Item Name: Aft Crosstube - High 407

WORK ORDER NON-CONFORMANCE / UPDATE

DART AEROSPACE LTD	Work Order: 83315
Description: Corrosion in center of Crosstube	126548
Drawing: D407-667-245	Repair Scheme: RS1027
Part No: D407-667-203 Aft Crosstube	Page: 1 of 2
Batch No: B85315	Qty: 1

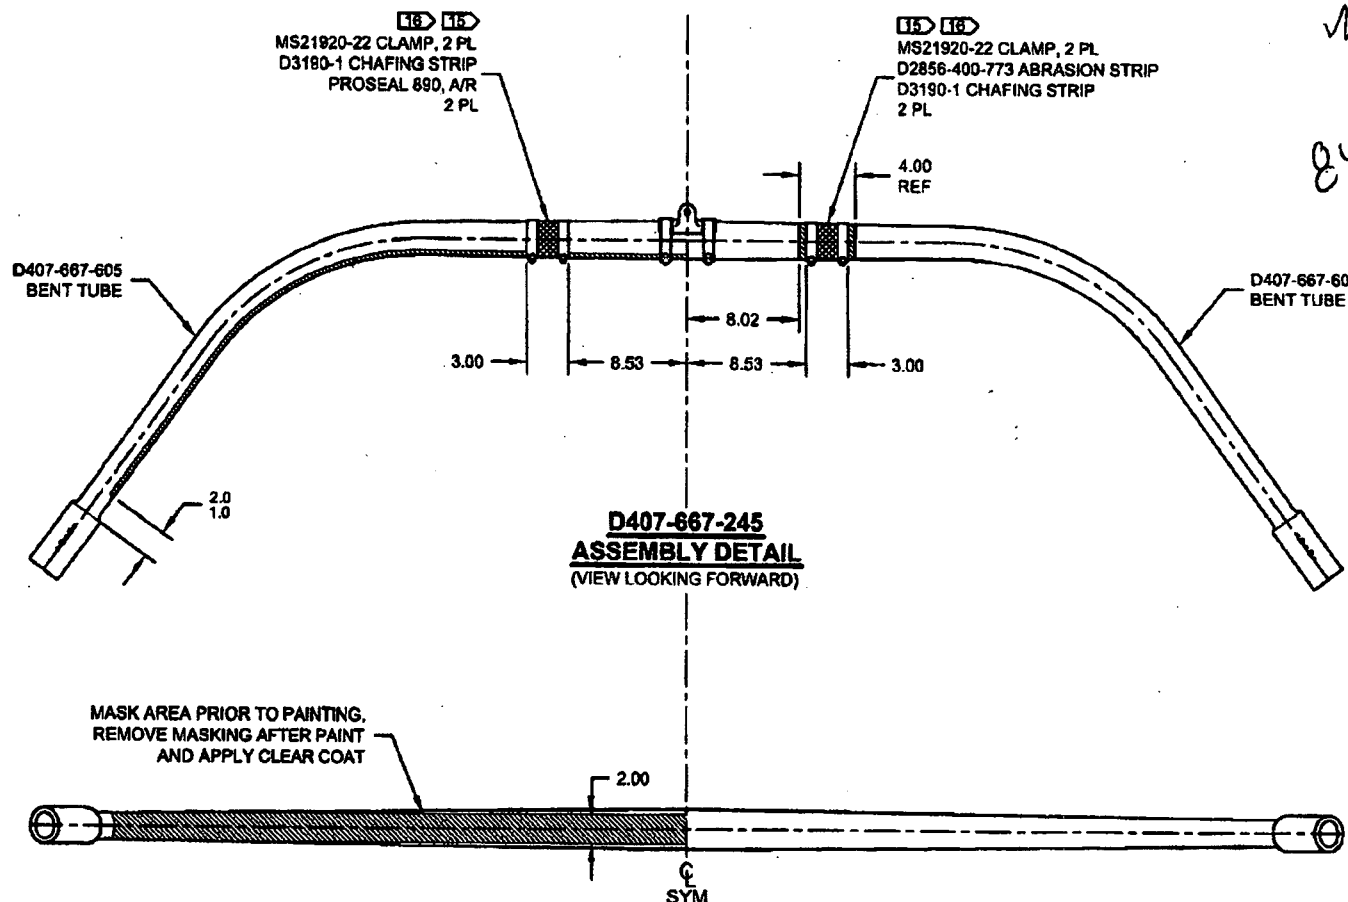
NOTES 2 AND 16, SHEET 1 ARE AMENDED AS FOLLOWS:

- 2) FINISH: CHEMICAL CONVERSION COAT PER DART QSI 005 4.1
PRIME INSIDE AND OUTSIDE PER DART QSI 005 4.2
MASK UNDERSIDE OF CROSSTUBE AS SHOWN (HATCHED AREA) AND
PAINT OUTSIDE PER DART QSI 005 4.2
REMOVE MASKING AND APPLY CLEAR COAT
- 15) APPLY A THIN COAT OF PROSEAL 890 ON INSIDE CONCAVE SURFACE OF D3190-1
CHAFING SHIELDS AND LET CURE PER MANUFACTURER'S INSTRUCTIONS. INSTALL
PROSEALED D3190-1 CHAFING SHIELDS ONTO CROSSTUBE BY APPLYING A THIN COAT
OF PROSEAL 890 ONTO CROSSTUBE. BE SURE TO ELIMINATE ANY AIR GAPS.

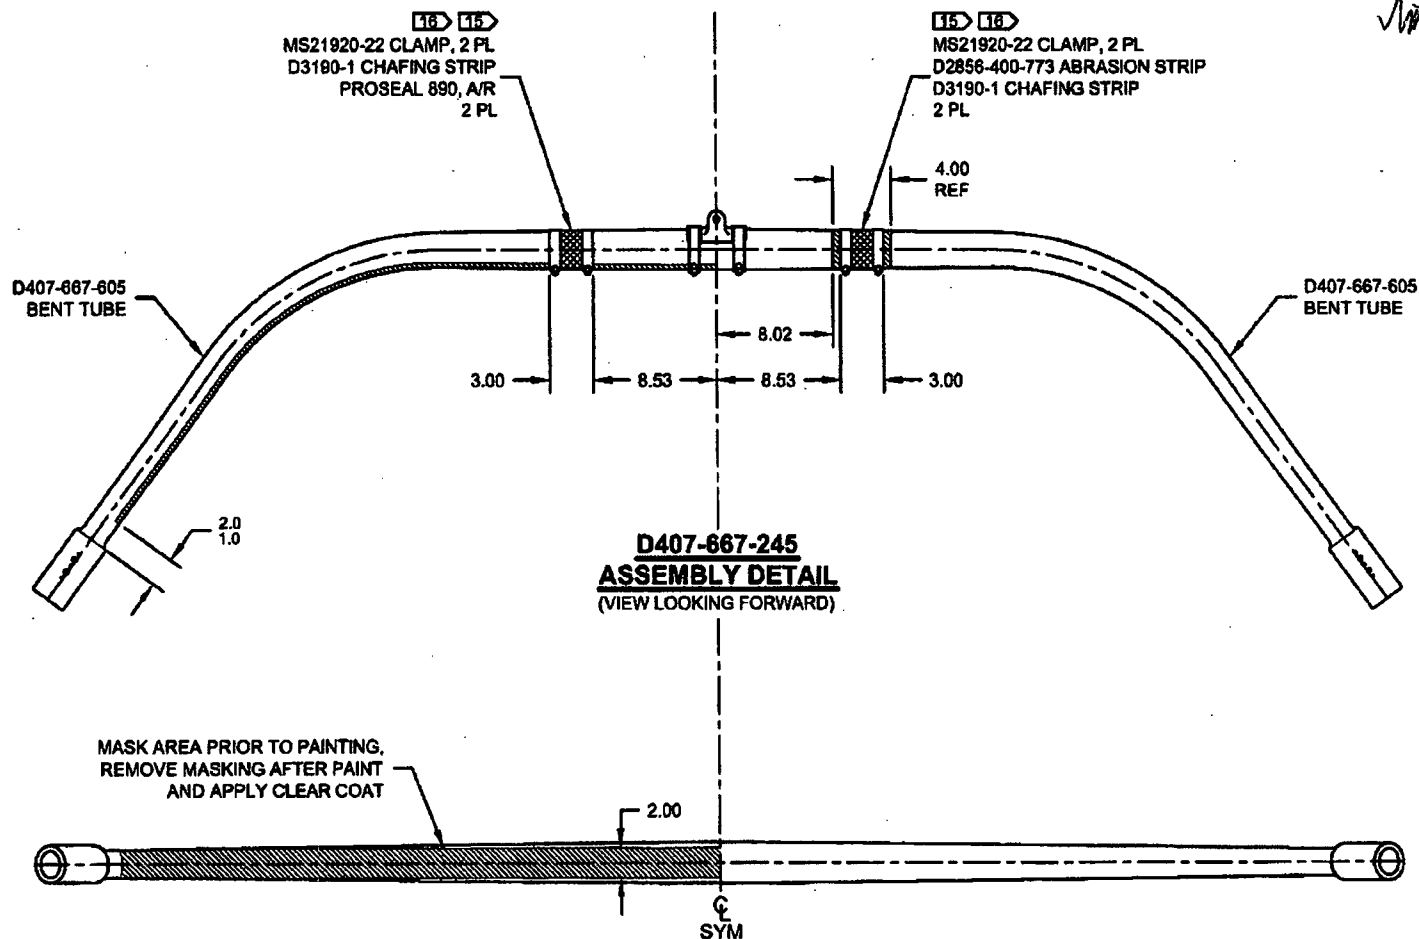
NOTES 2 AND 15, SHEET 1 ARE AMENDED AS FOLLOWS:

- 2) FINISH: CHEMICAL CONVERSION COAT PER DART QSI 005 4.1
PRIME INSIDE AND OUTSIDE PER DART QSI 005 4.2
MASK UNDERSIDE OF CROSSTUBE AS SHOWN (HATCHED AREA) AND
PAINT OUTSIDE PER DART QSI 005 4.2
REMOVE MASKING AND APPLY CLEAR COAT
- 15) APPLY A THIN COAT OF PROSEAL 890 ON INSIDE CONCAVE SURFACE OF D3190-1
CHAFING SHIELDS AND LET CURE PER MANUFACTURER'S INSTRUCTIONS. INSTALL
PROSEALED D3190-1 CHAFING SHIELDS ONTO CROSSTUBE BY APPLYING A THIN COAT
OF PROSEAL 890 ONTO CROSSTUBE. BE SURE TO ELIMINATE ANY AIR GAPS.
